CONTRACT CHANGE ORDER NO. 31454
SHEET 2 OF 3

SAN FRANCISCO OAKLAND BAY BRIDGE
EAST SPAN SEISMIC SAFETY PROJECT
SELF-ANCHORED SUSPENSION BRIDGE
(SUPERSTRUCTURE & TOWER)

TEST RIG DETAILS NO. 29

TEST RIG DETAILS NO. 30

LAYOUT PLAN - TEST RIGS #14, 15, 16, 17
(MODIFIED FROM TEST RIGS #1, 2, 3, 4)

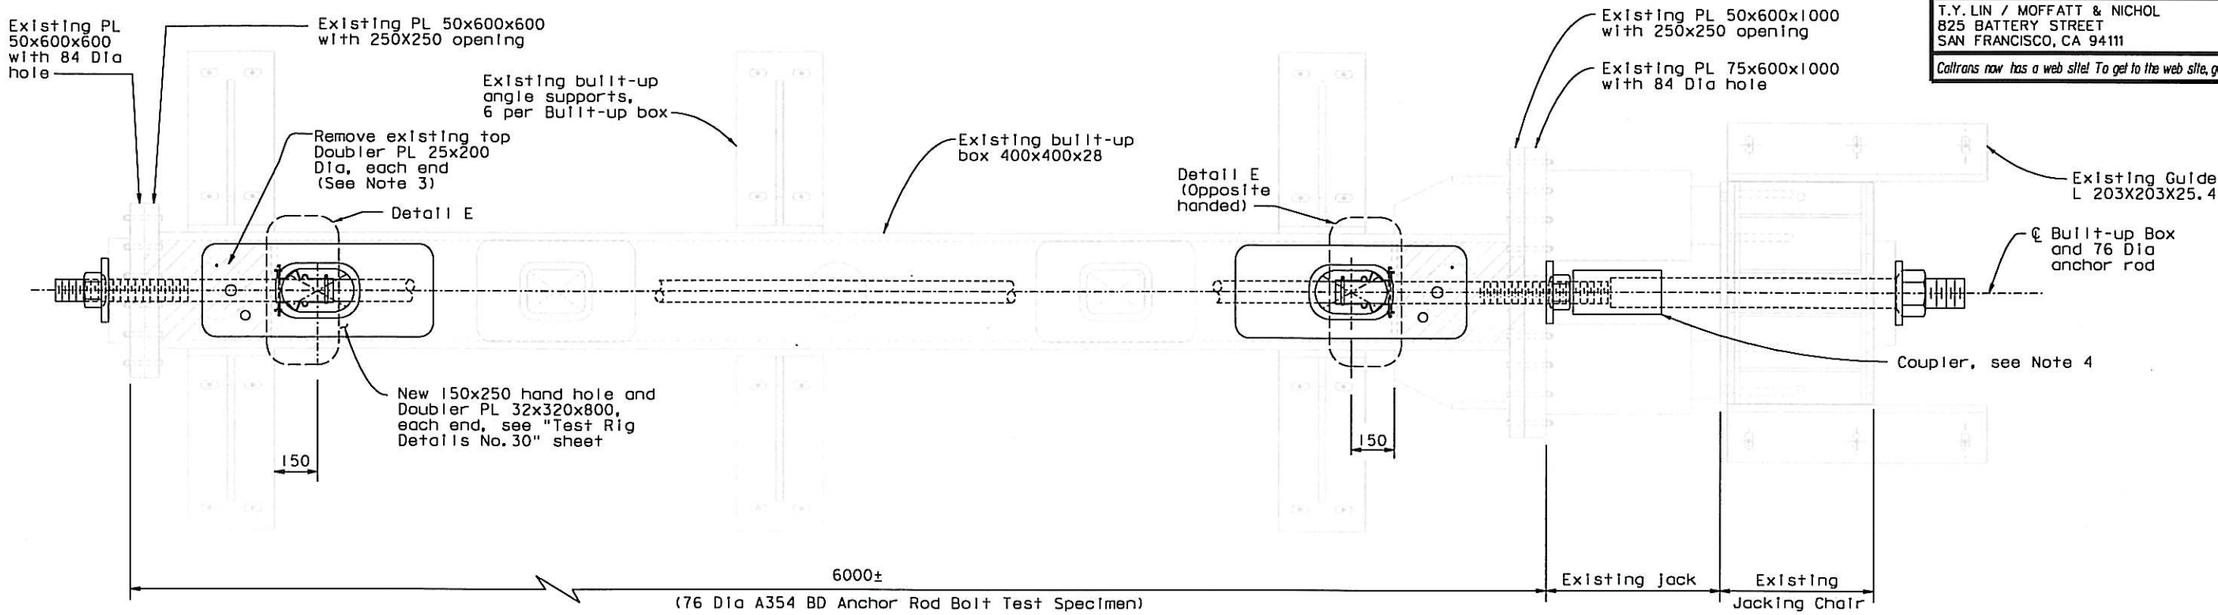
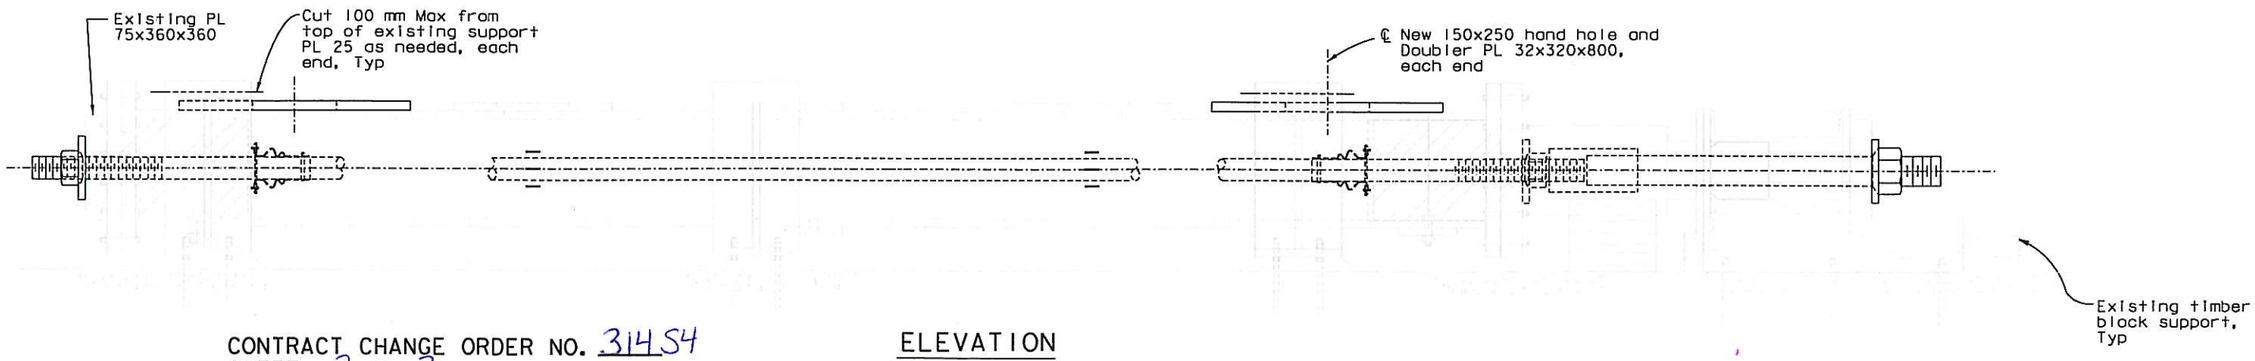
1. See "Test Rig Details No.3" sheet for Details and Notes of existing Test Rig #1 thru #4.
2. See "Test Rig Details No.30" sheet for pre-use inspection and modification procedure notes.
3. Top Doubler PL 25x200 Dia shall be removed by grinding off existing welds.
4. For coupler detail, see "Test Rig Details No.6" sheet. Couplers for ungalvanized rods shall not be tapped oversized.
5. For Detail E, see "Test Rig Details No.30" sheet.

ADDITIONAL HAND HOLE AND DOUBLER PL DETAIL (Jacking end opposite handed)

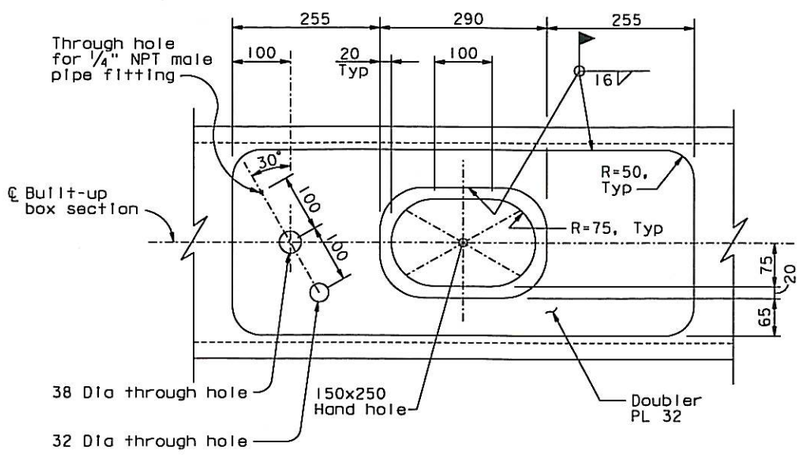
1. Fabricate new hand holes.
2. Grind off existing top Doubler PL 25x200 Dia.
3. Grind flush existing weld crowns under footprint of new doubler plates.
4. Weld on new doubler plates.
5. Drill/ tap new holes for instrumentation.
6. Caulk-seal and paint all existing instrumentation holes.
7. Clean and remove all rust stains inside the wet chambers.
8. Repair damaged paint on all interior wetted surfaces of the wet chambers, including inside of holes. Surface preparation and application procedure shall be per manufacturer's recommendations.
9. The Contractor may sequence the above work according to his means and methods.
